TECHNICAL EVALUATION REPORT
NORTH ANNA POWER STATION UNITS 1 AND 2
STATION BLACKOUT EVALUATION

TAC Nos. 68572 AND 68573

Final
September 24, 1990

U.S. Nuclear Regulatory Commission
Washington, D.C. 20555

FIGURE 1

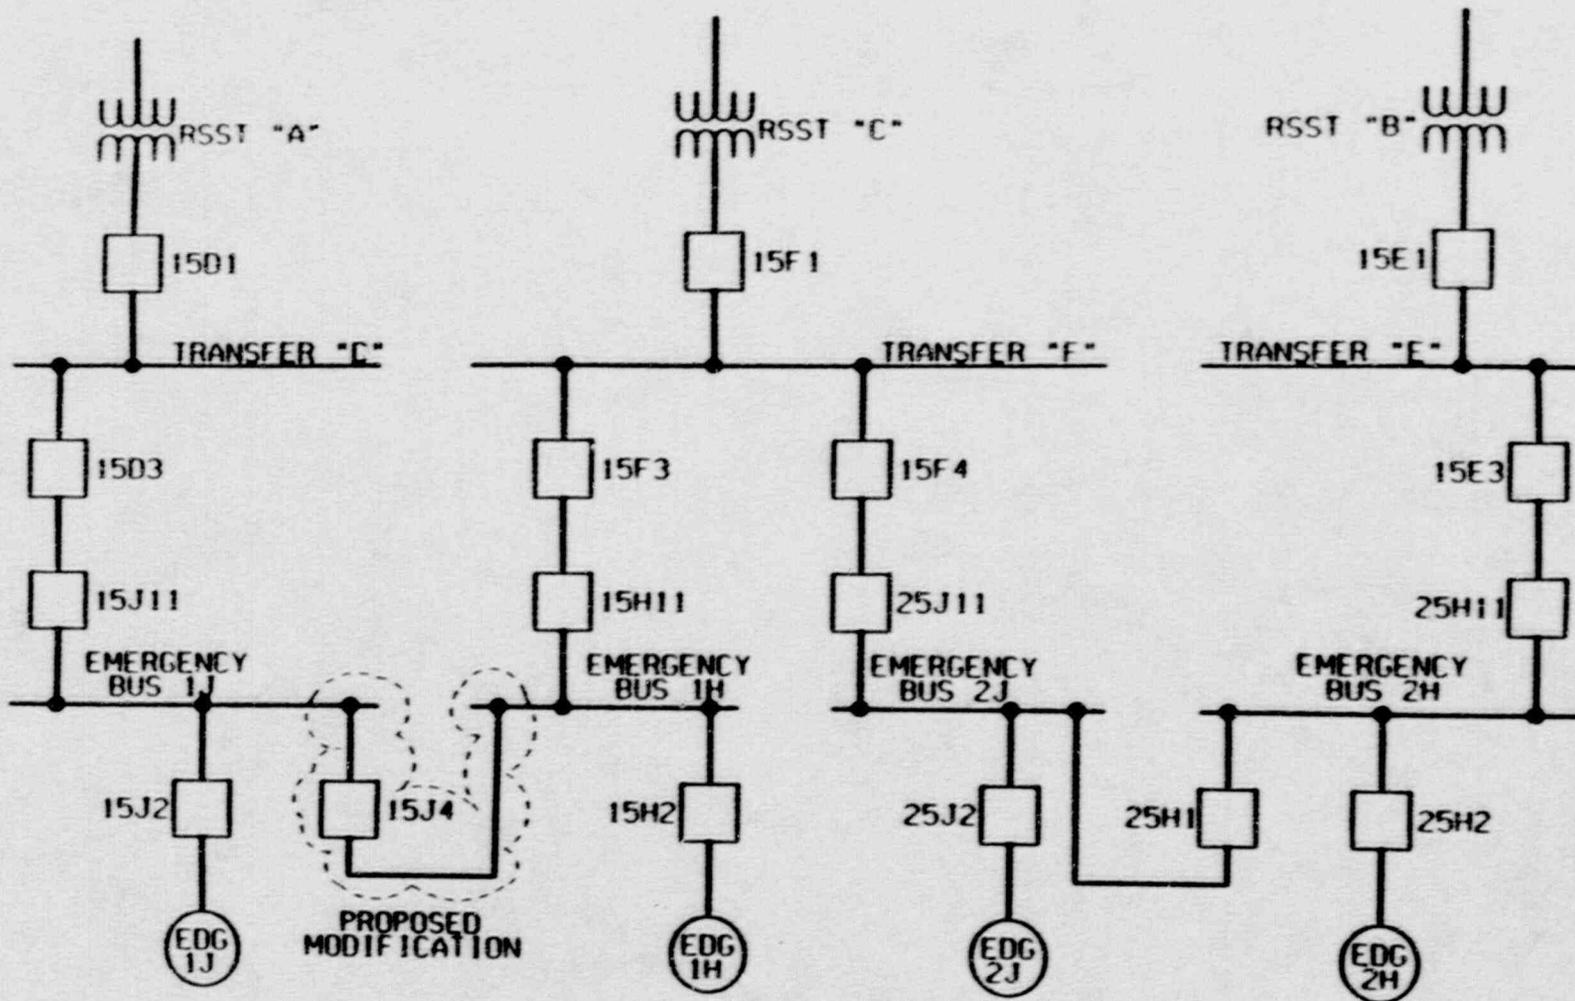
1. All offsite power sources are connected to the plant through one switchyard.
2. At each unit, there are two divisions of 4.16 kV emergency buses, each division is normally powered from a separate and independent offsite power source through a reserve station service transformer (RSST), see Figure 1 (20).
3. Upon the loss of RSST "A," "B," or "C," (loss of preferred power source), the connected emergency bus(es), i.e. Bus 1H, 2H, 1J or 2J, can only be powered through manual closure of circuit breakers which tie independent divisions together. This means of providing

power does not conform to the operating guidance regarding the independence of the emergency trains in a unit.

Using the guidance provided in Table 5 of RG 1.155 the independence of the offsite power system grouping is "I3." This conclusion is driven by the configuration discussed in item 3 above.

The licensee's proposed AAC power source configuration, see Figure 1, does not conform to an acceptable configuration provided in NUMARC 87-00 Supplemental Questions/Answers under Question C.1 (15). The licensee addressed this non-conformance for the Surry power station by proposing to install a non-safety grade cross-tie between the transfer Buses "D" and "E" (16). The licensee needs to commit to the same modification for the North Anna Units 1 and 2. This is needed to have an acceptable cross connect to power the needed air compressor from the operating EDGs.

The licensee classifies the site as "I1/2." Our review indicates that the site is "I3" since upon loss of power from either RSST "A," "B," or "C" (preferred power sources) only one division of emergency buses can be powered. The RG 1.155 position is that all emergency buses be powered.
